FLOODING

Comments on PDPs Updated Submission by Ben Throssell (dated 6th July and 6th August)

Figure 1 THIS PHOTO SHOWS WHERE THE OHOKA STREAM SOUTH BRANCH IS RESTRICTED BY THE ENCROACHMENT OF A NOW FALLEN TREE ROOT SYSTEM INTO THE STREAM. (THE TRUNK IS VISIBLE ON THE LEFT.) HOW DOES FACTORS SUCH AS THIS GET TAKEN INTO ACCOUNT IN THE MODELING ?

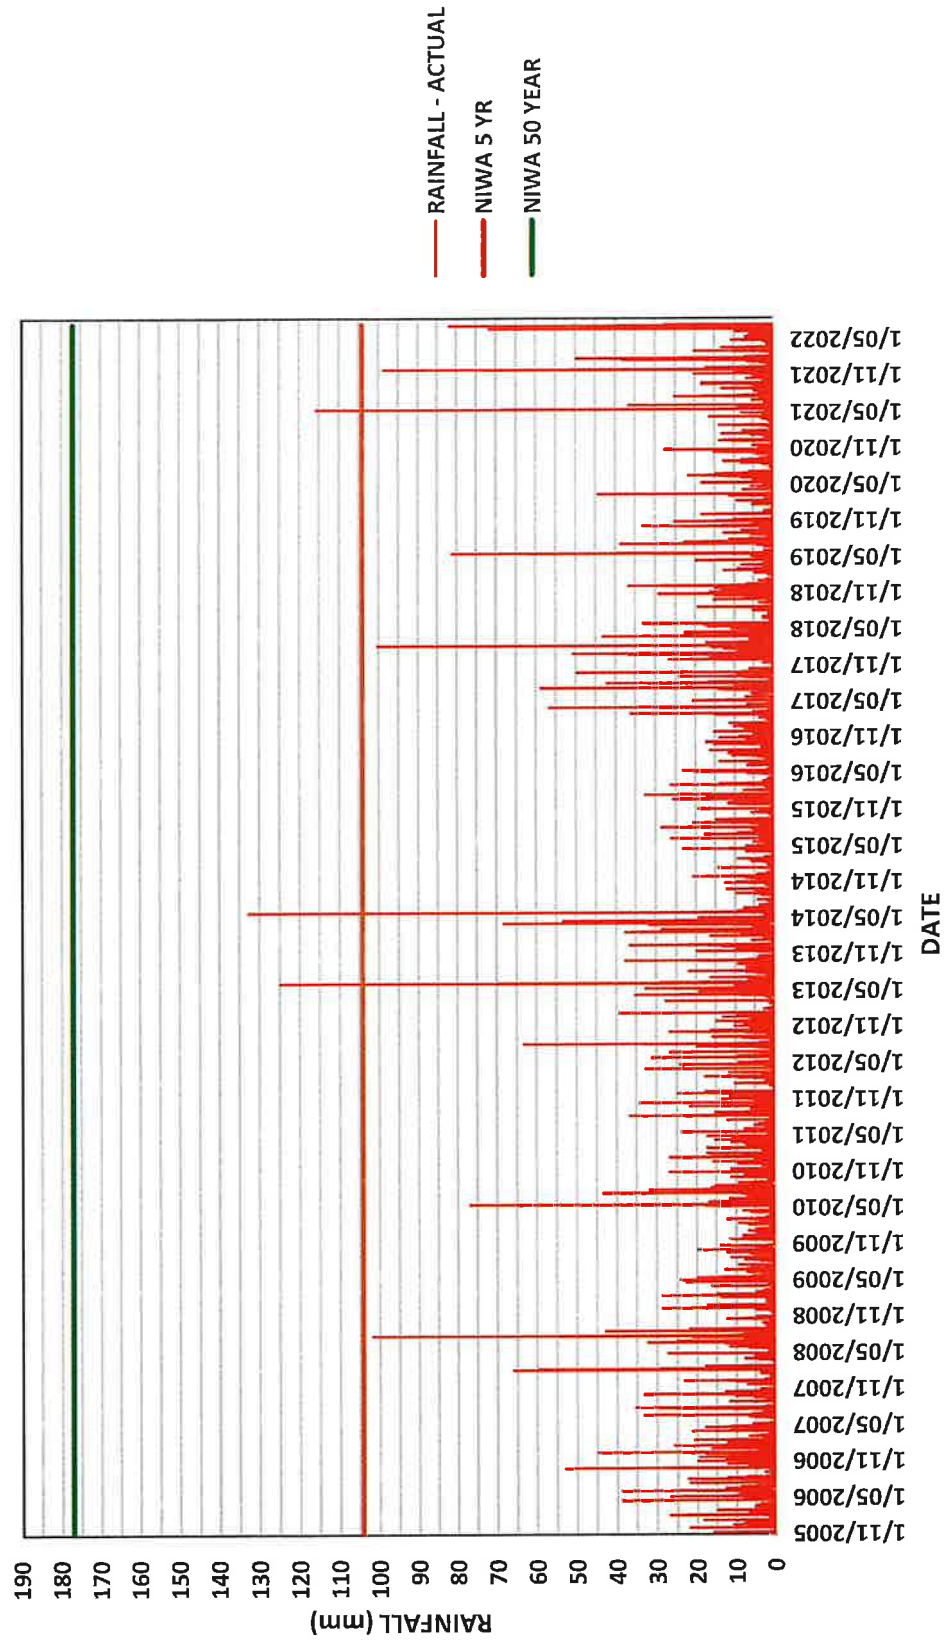
I also note that there is no mention in the model as to the physical characteristics of the waterways in the area. What dimensions have been allowed for in the model and what account is taken of the 'obstructions', both temporary and permanent that exist in these waterways? For example the Ohoka Stream South Branch is constrained where it exits our property due to the encroachment of the bank into the stream, from the root structure of a large tree that was planted many years ago. When the tree fell down two years ago I asked WDC if the restriction could now be removed to reduce the flooding that occurs, however I was told that ECAN would not permit this. I also note that immediately adjacent to this restriction our neighbour has removed the bank and created a discharge point, complete with multiple piped drains which discharge into the stream. I assume that the model does not take either the restriction, or the additional discharge into account. There are also some drains adjacent to our property which are essentially blocked by vegetation as there is no maintenance carried out by the owners or the WDC. At times of heavy rain, rather than conveying water away as part of the overall drainage system, these can overflow resulting in water running onto our property. (Reference is made to these being considered as being 'blocked' in the model.) I have included two photos showing the encroachment onto the stream and the additional drainage.
